Dominion Nuclear Connecticut, Inc.
Millstone Power Station
Rope Ferry Road
Waterford, CT 06385

Millstone Nuclear Power Station, Unit Nos. 2 and 3
Technical Specifications Change Requests 2-21-01 and 3-18-01
Relocation of Selected Technical Specifications Related to the Reactor Coolant System
and Plant Systems

Technical Specifications Change Request 2-21-01
Relocation of Selected Technical Specifications
Related to the Reactor Coolant System and Plant Systems
Marked Up Pages

Technical Specifications Change Request 3-18-01
Relocation of Selected Technical Specifications
Related to the Reactor Coolant System and Plant Systems
Marked Up Pages

Critical Area
Figure 3.7-1

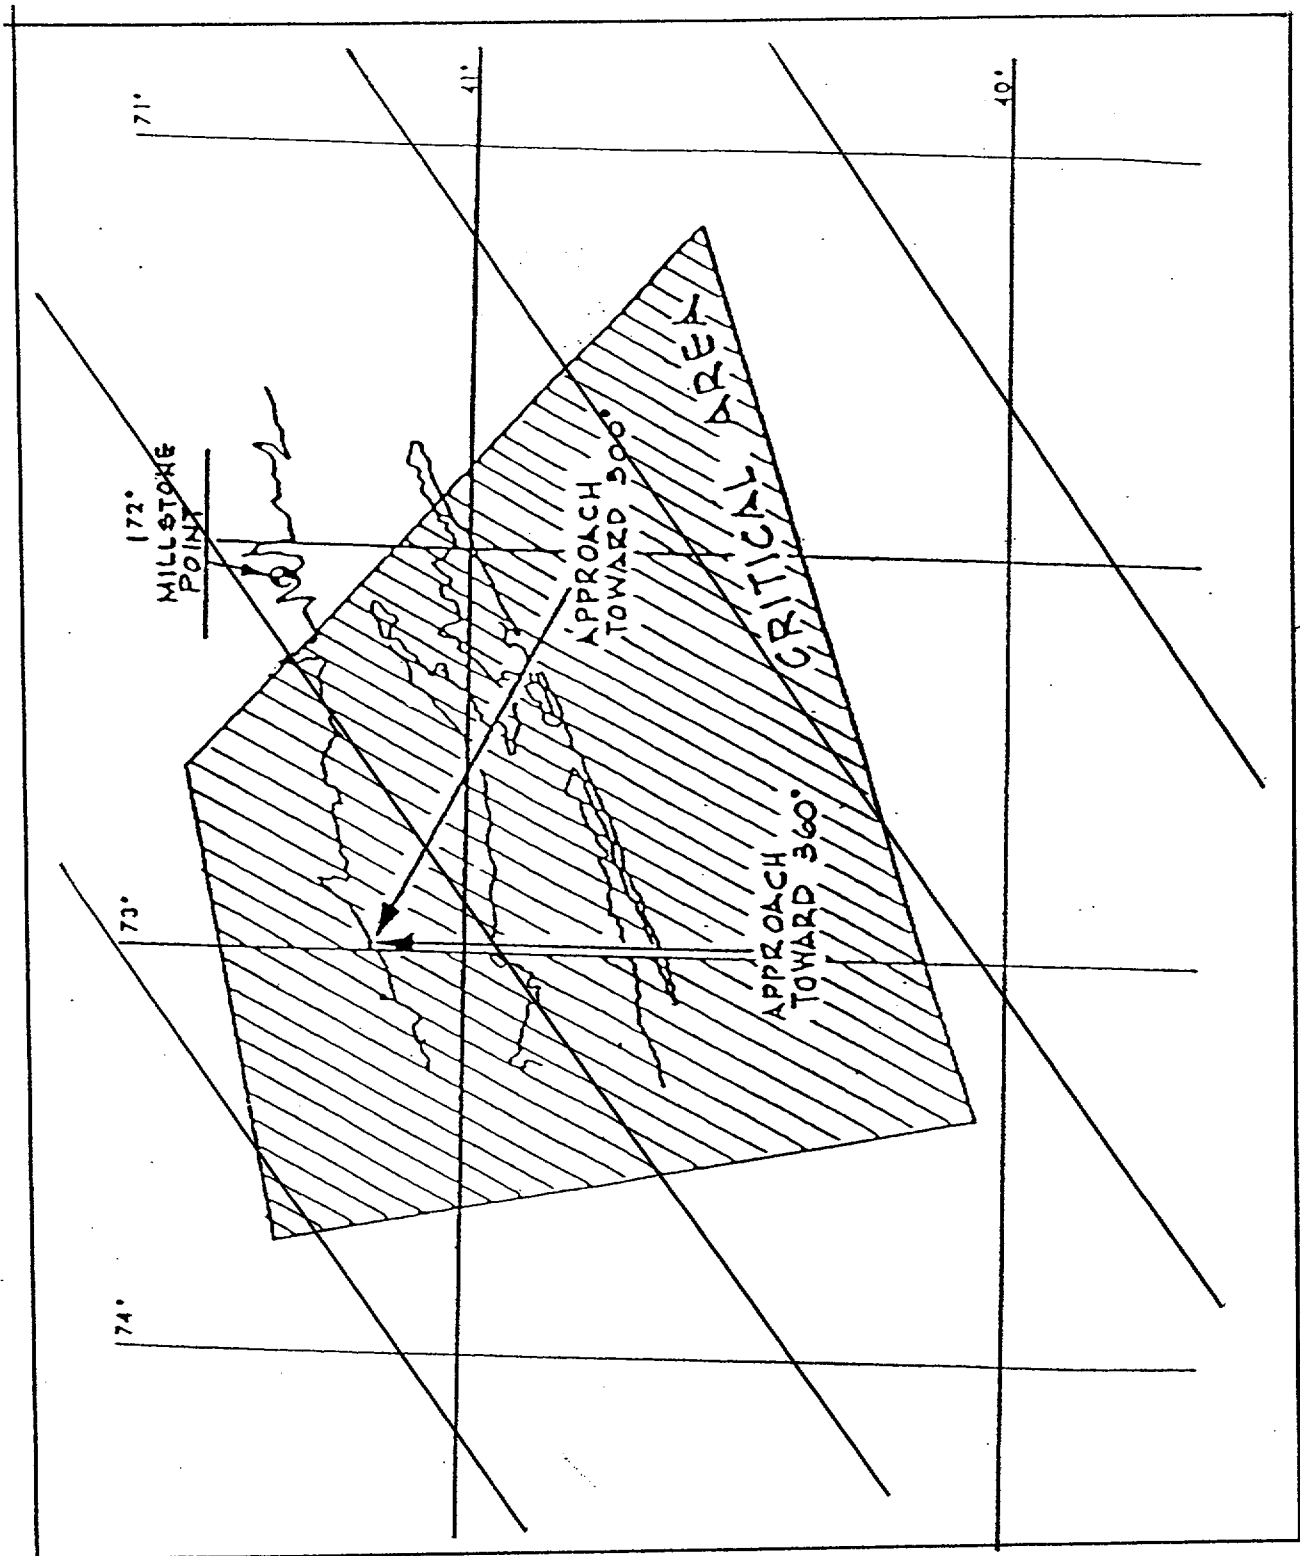
TS 3/4.7.5.1 for Millstone Unit No. 2 and 3/4.7.6 for Millstone Unit No. 3 are proposed to be relocated to the respective facility's TRM. TS 3/4.7.5.1 for Millstone Unit No. 2 ensures that one service water pump motor will be protected against flooding to a minimum elevation of 28 feet. The service water pump motors are normally protected against water damage to an elevation of 22 feet. If the water level is exceeding plant grade level or if a severe storm is approaching the plant site, one service water pump motor will be protected against flooding to a minimum elevation of 28 feet to ensure that this pump will continue to be capable of removing decay heat from the reactor. Action to provide pump motor protection will be initiated when the water level reaches plant grade level in order to ensure operator accessibility to the intake structure. TS 3/4.7.6 for Millstone Unit No. 3 ensures that the service water pump cubicle watertight doors will be closed and the pump cubicle sump drain valves will be closed before the water level reaches the critical elevation of 14.5 feet Mean Sea Level (MSL). Elevation 14.5 feet MSL is the floor elevation of the service water pump cubicle.

With the water level exceeding either plant grade or with three or more of the above specified meteorological conditions being exceeded simultaneously, immediate initiate action to protect at least one service water pump motor against flooding to a minimum elevation of 28 feet; complete this protective action within 2 hours.

Replace with

Replace with

FIGURE 4.7-1
SAMPLE PLAN 2) FOR SNUBBER FUNCTIONAL TEST

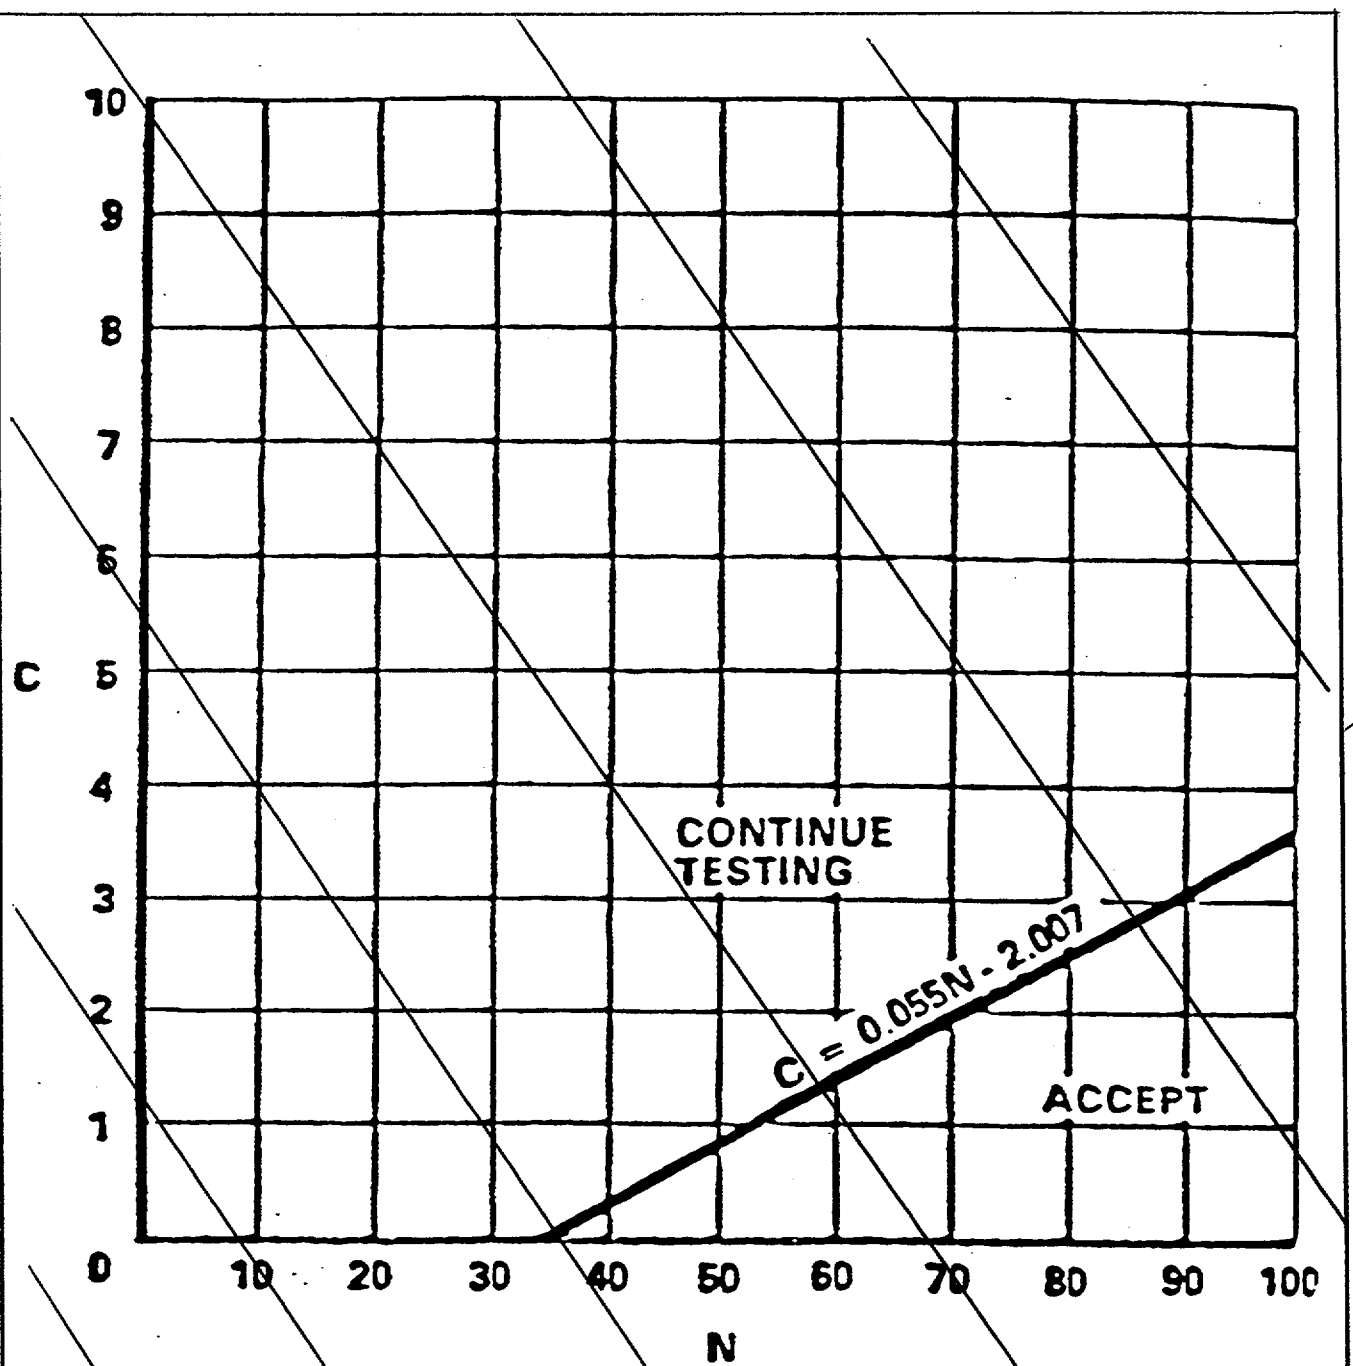
Replace with
THIS PAGE INTENTIONALLY LEFT BLANK
